NSLPP MEETING HELD ON 04/09/2024

ADDRESS/WARD: 71 Pine Street, Cammeray

APPLICATION NO: DA 348/2023

PROPOSAL: Additions, alterations to first and ground floor levels, refurbishment of existing terrace, and installation of new vergola awning above ground level terrace

Figure 5: East and West Elevation (Source: Architectural Plans).

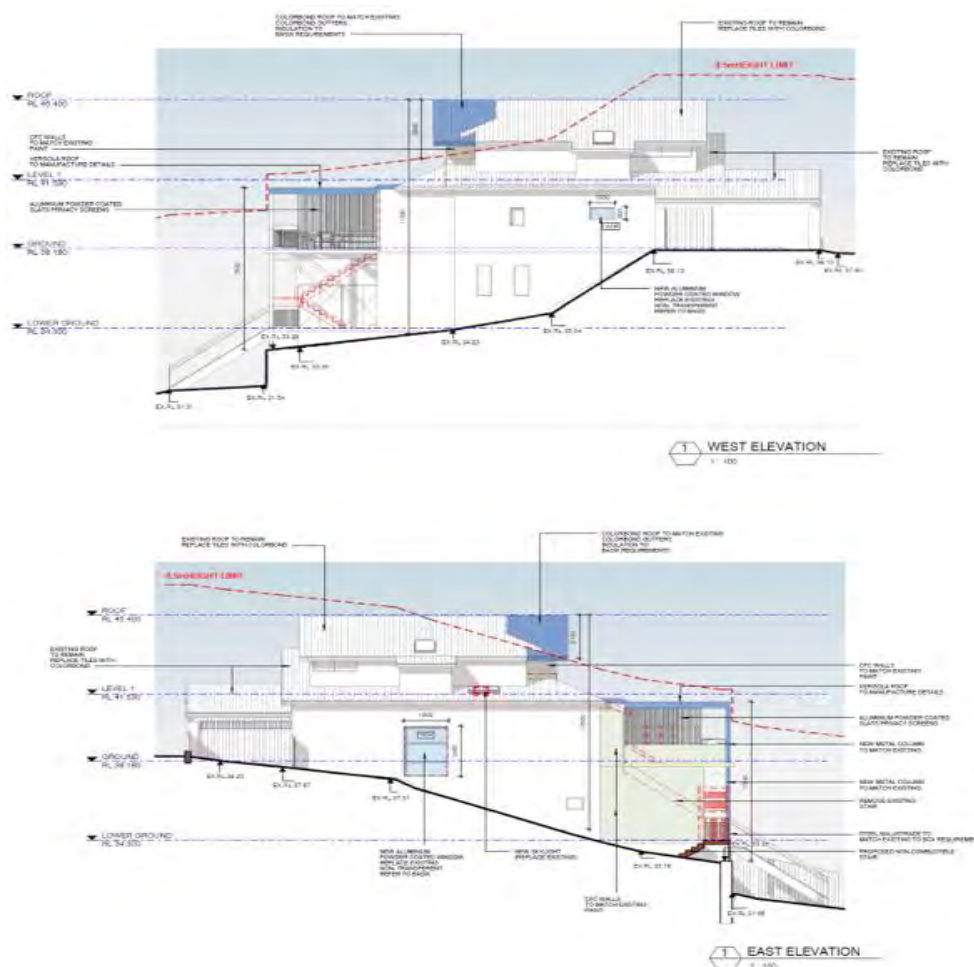
The subject site has a maximum permitted building height of 8.5m pursuant to sub-clause 4.3(2) in *NSLEP 2013*. The existing building exceeds the building height standard, with a maximum height of 10.85m. Whilst the proposal does not technically increase the height of the dwelling, the proposed works extend the existing primary roof ridgeline towards the north which effectively increases the degree of non-compliance as a result of the sloping topography of the site. It should be noted that the enclosure of the First-Floor level bedroom balcony and roof extension works all take place above the maximum building height plane.

The proposal results in an exceedance of the height standard of 2.8m which represents a 33% variation as demonstrated in Figure 5 below.
